Appendix I of RNTPC
Paper No. A/NE-KLH/645A

**APPLICATION FOR PERMISSION
UNDER SECTION 16 OF
THE TOWN PLANNING ORDINANCE
(CAP. 131)**

擬議臨時公眾停車場(只限私家車)連附屬設施(為期五年)

A/NE-KLH/645
回應渠務署的擬問

Drainage Proposal- Application Boundary and Catchment Area

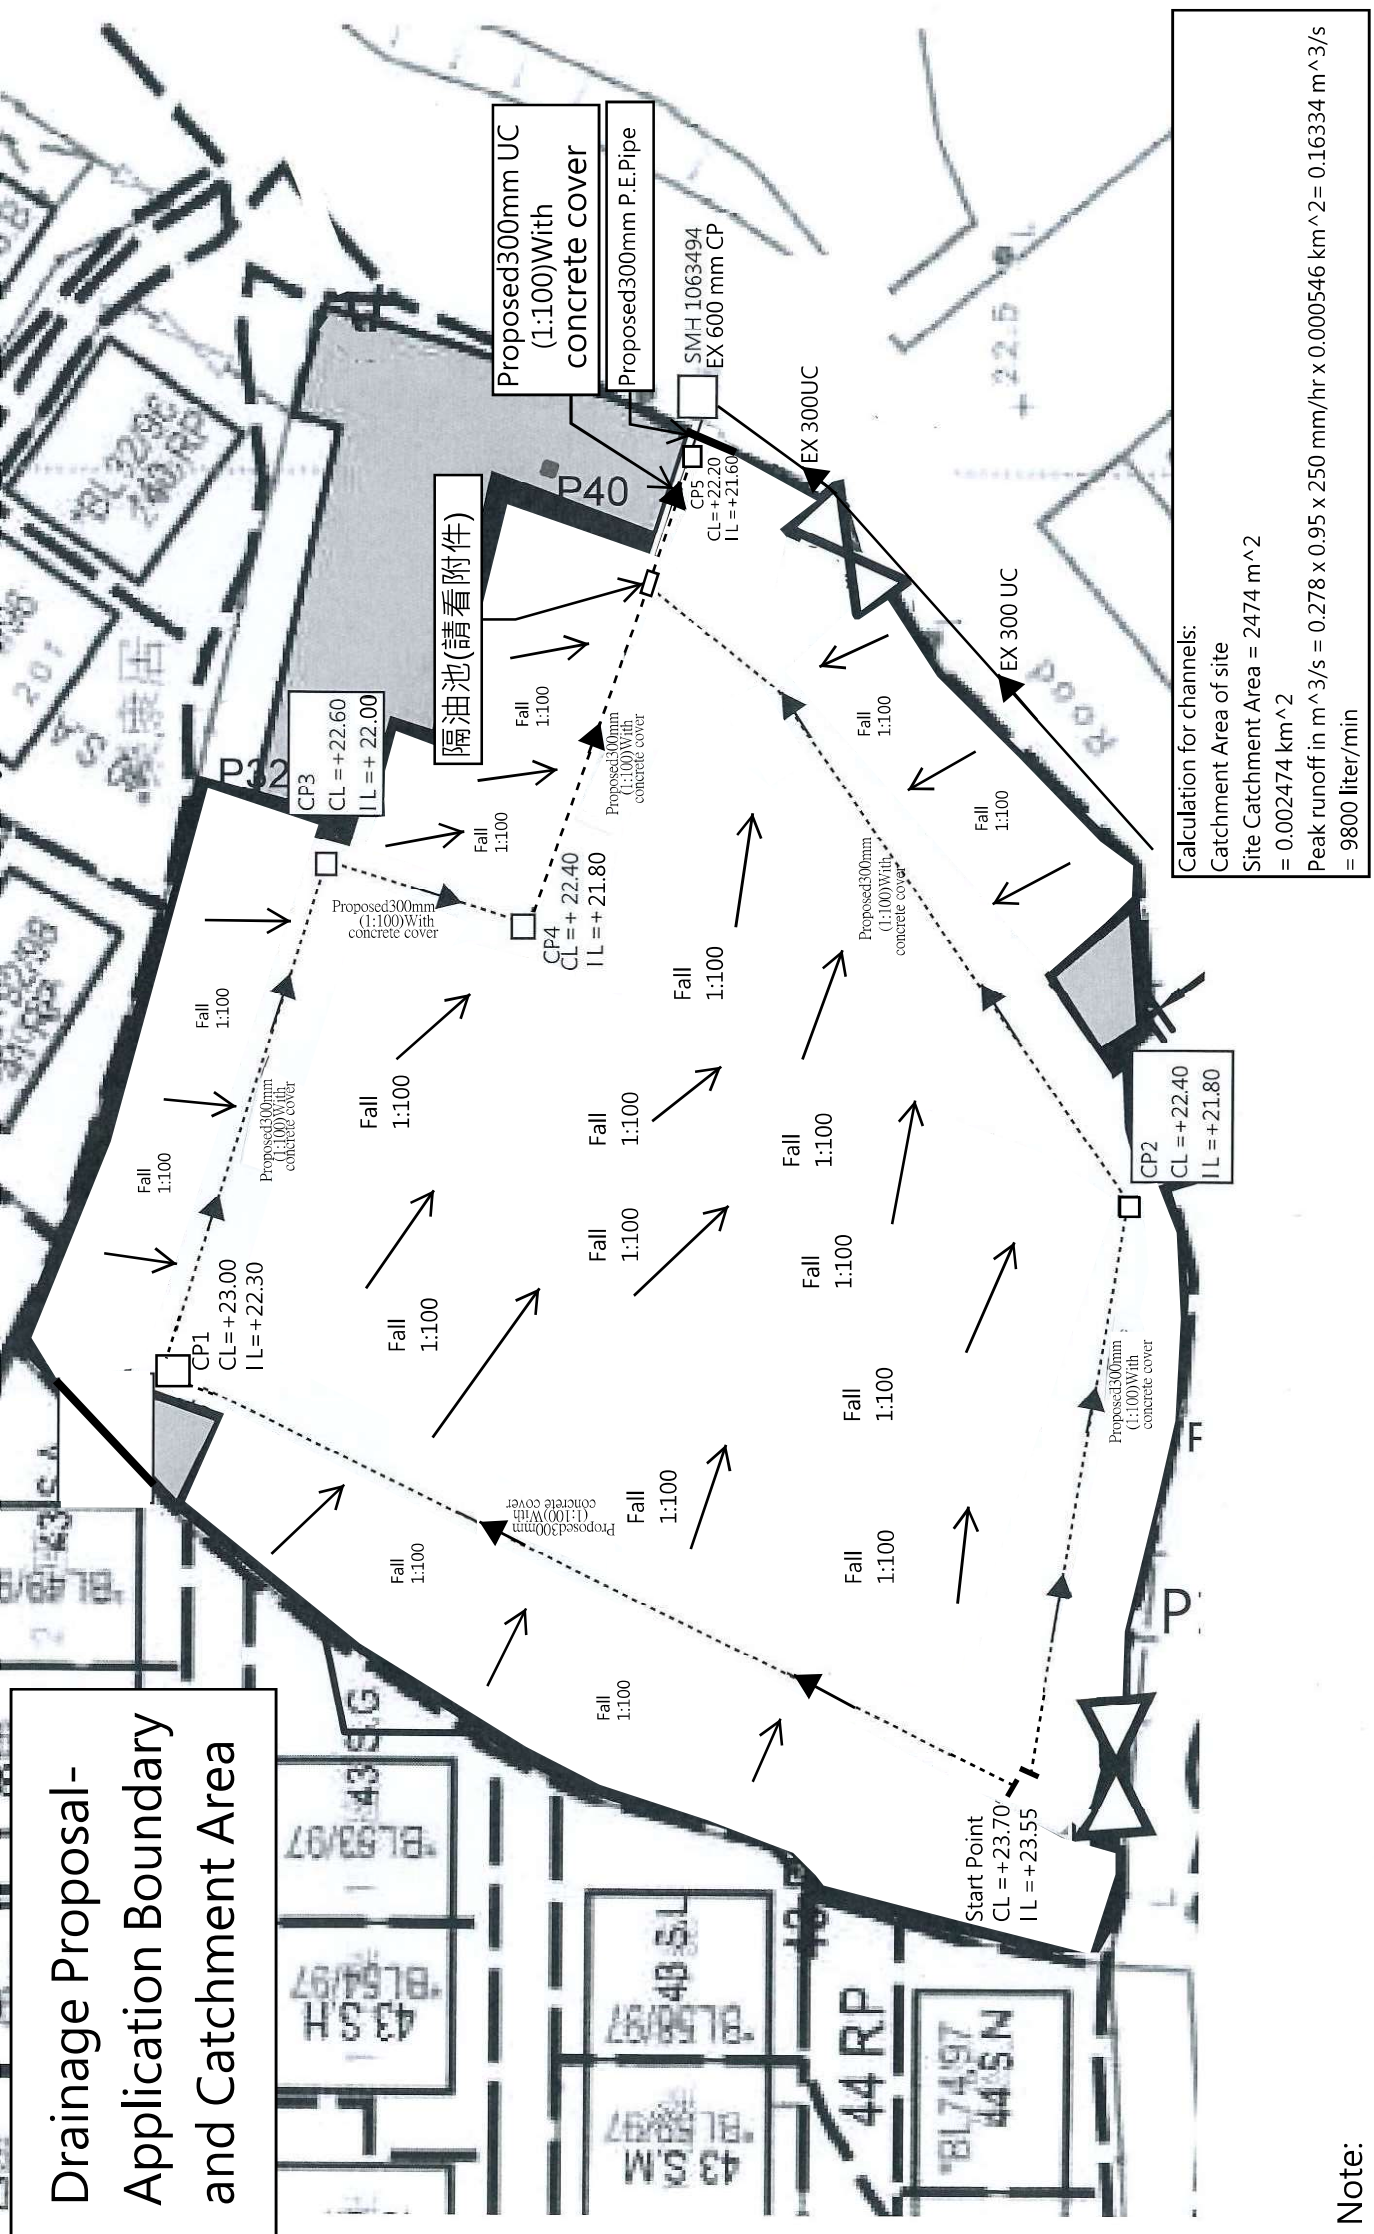
Comments from Water Supplies Department (Contact Person: Ms. Victoria SUEN at 2152 5752):

Based on the provided information, there are risks of contamination to the WGG due to the operation and management of the public vehicle park and its ancillary facilities. In order to safeguard the water quality in WGG, the Applicant shall provide a risk assessment report to prove and demonstrate to the satisfaction of the Water Supplies Department (WSD) that there is no material increase in pollution effect resulting from the proposed development. In particular, the Applicant shall provide evidences and/or control measures to ensure that the following conditions are met:

- (a) No discharge of effluent or foul water into adjoining land, storm water drain, channel, stream or river course is allowed. Such foul water or effluent shall be collected and disposed of outside WGG.

- (b) All solid waste and sludge arising from the proposed development shall be disposed of properly outside WGG.
- (c) The use and storage of pesticides, herbicides, toxicants, chemical solvents, larvicidal oil, rodenticide, tar and petroleum oil are strictly prohibited in WGG.

- (d) No chemicals including fertilizers and detergents shall be used/stored without the prior approval from the Water Authority.
- (e) Oil leakage and spillage are not allowed within WGG at all time. Oil and grease decontamination kit such as absorbent pads shall be made available to decontaminate any possible oil leakage or spillage.

- (f) The office, meter cabinet, vehicle park and their associated activities shall be located away from any water courses as far as possible. Signage for alerting not to pollute WGG should be displayed.

- (g) Fencing shall be erected on the sides facing the nearest stream course to trap all wind-blown litters within the site of development.
- (h) Site surface should be impermeable to oil and grease as far as practicable. Any soil contaminated with fuel leakage shall be immediately removed off site and the voids arising from removal of contaminated soil shall be replaced by suitable material to the satisfaction of the Water Authority.

- (i) Vehicle park shall be surrounded by kerbs and drains. Drainage traps such as grease traps and petrol interceptors shall be installed at each of the drainage outlets and shall be under proper maintenance. All such drainage traps shall have sufficient capacity to ensure the proper interception and collection of fuel and lubricants in surface run-off for off-site disposal. Proper maintenance and disposal records should be maintained.

- a 我等停車場不會設置洗手間因此不會產生污水，同時我等會在停車場出入口及場內當眼處貼出告示，停車場內嚴禁進行車輛清潔事宜。
- b 所有在開展工作後，所有污泥，和固體廢物都會全部運往堆填區棄置。
- c 我等會在停車場出入口及場內當眼處貼出告示嚴令禁止存放及使用化學物品包括農藥，除草劑，毒藥，化學溶劑，幼虫油，剎鼠劑，焦油及石油。
- d 停車場絕對不允許在場內存放或使用肥料及清潔劑在內的化學物品。
- e 我等會派出員工每小時巡視停車場內車輛的狀況防止漏油事件發生，同時場內已存放100件吸油墊，五套油脂淨化套件以防止漏油事件發生。如油污滲到泥土時，我等會將被污染的泥土全部清除，之後將新的泥土填補有關位置。
- f 我等預設的辦公室只用作存放吸油墊，油脂淨化套件及監控系統，而電錶房的位置最小距離河道50米的地方安放。
- g 鄰近河道位置我等已設置圍板，絕對不會有垃圾被大風吹離停車場。
- h 場地內地面已鋪上1層碎石及石粉混合物料，經重型壓土機壓實，如果不幸有漏油事件發生，我等會將有關土壤全部清除，再填補上新的泥土。
- i 我等場地內已設置排水渠，在每個轉接位都設有隔沙坑，在尾段還設有一個標準隔油池，防止油污經過排水渠流至河道。(請看附件現場相片)
- j 如獲批准我等場地不須要進行任何工程，亦不會產生污水及污泥(請看附件現場相片)
- k 電錶房內不會存放任何有污染性物品，而辦公室亦只會存放吸油墊及油脂淨化套件和監控設備。
- l 停車場運作期間，將會依照(集水區作業條件)的指引。

- g 鄰近河道位置我等已設置圍板，絕對不會有垃圾被大風吹離停車場。
- h 場地內地面已鋪上1層碎石及石粉混合物料，經重型壓土機壓實，如果不幸有漏油事件發生，我等會將有關土壤全部清除，再填補上新的坭土。
- i 我等場地內已設置排水渠，在每個轉接位都設有隔沙坑，在尾段還設有一個標準隔油池，防止油污經過排水渠流至河道。(請看附件現場相片)
- j 如獲批准我等場地不須要進行任何工程，亦不會產生污水及污泥(請看附件現場相片)
- k 電錶房內不會存放任何有污染性物品，而辦公室亦只會存放吸油墊及油脂淨化套件和監控設備。
- l 停車場運作期間，將會依照(集水區作業條件)的指引。
- m-p 我等停車場如獲批准，我等不會進行任何挖掘工程，包括以上各項聲明在內，隨函我等附上有關場地現場相片以作證明。

車輛出入模擬圖

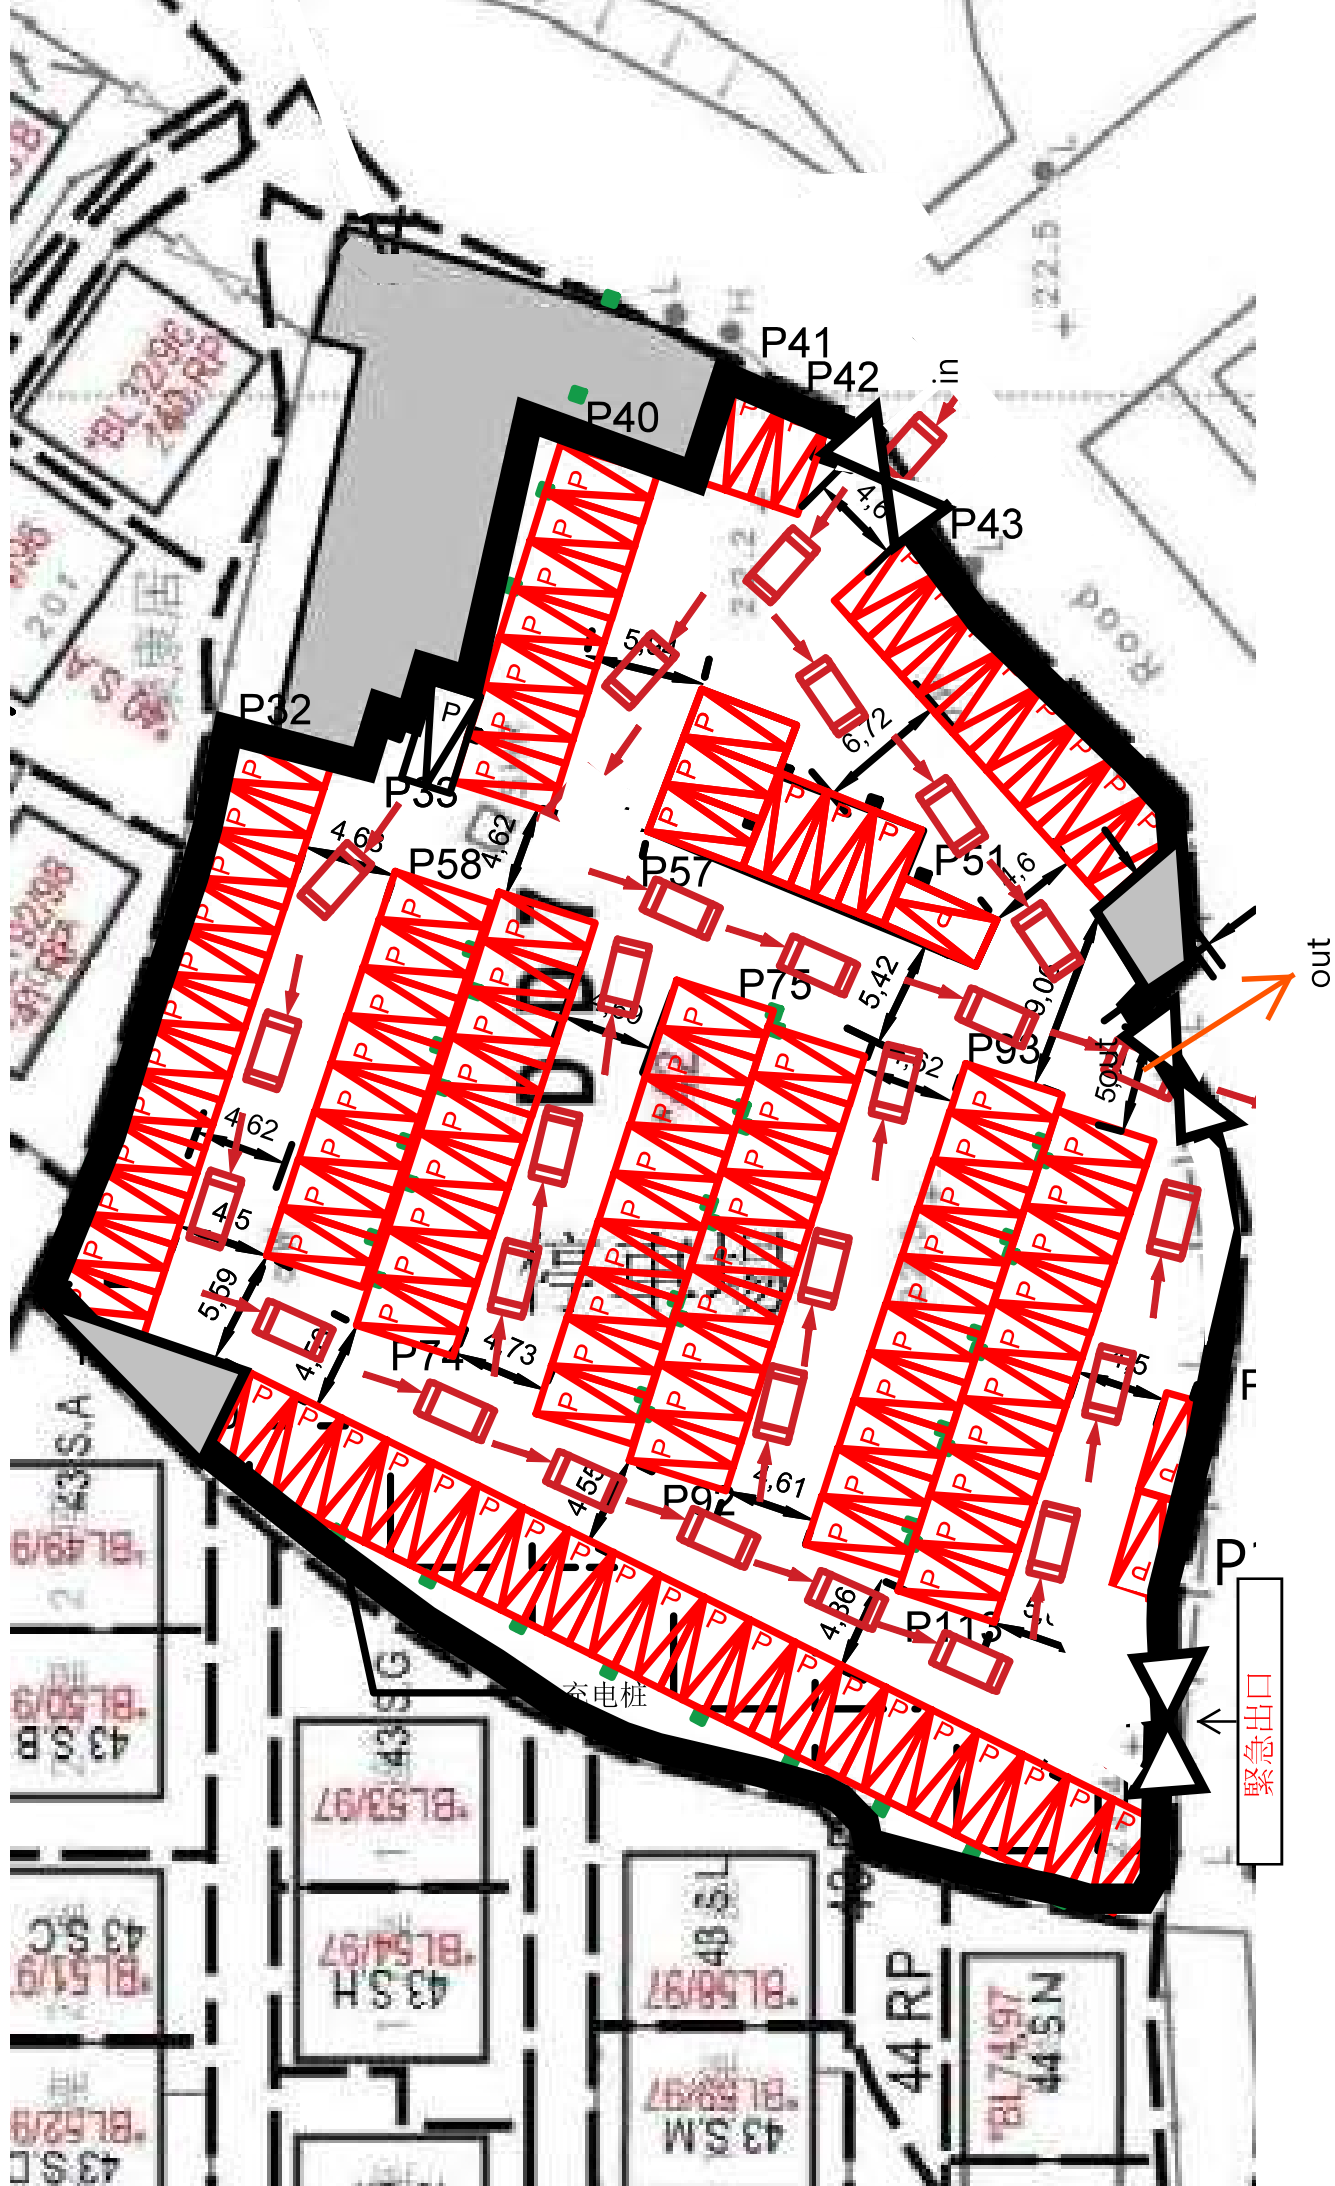
1. Sufficient maneuvering spaces shall be provided within the subject site or its adjacent area. No vehicles are allowed to queue back to public roads or reverse onto/from public roads.

2. The local track leading to the subject site is not under TD’s purview. You shall obtain consent of the owners/managing departments of the local track for using it as the vehicular access to the subject site.

我等停車場大部份用作村民月租之用，車場設有二個出入口設定為一出入因此車輛絕對不會因對頭車情況出現而令至阻塞。同時車場內設置指示牌要求車主及駕駛人士必須遵守指示行車。

車場以外力土地全部為政府土地，一般車輛只作為路過用途時政府部門，村長和村民都會給與許可，村內政府土地不時有交通警察進行檢控違例泊車事而，而我等在是次申請前已徵詢村長意見當時村長亦沒有任何意見。
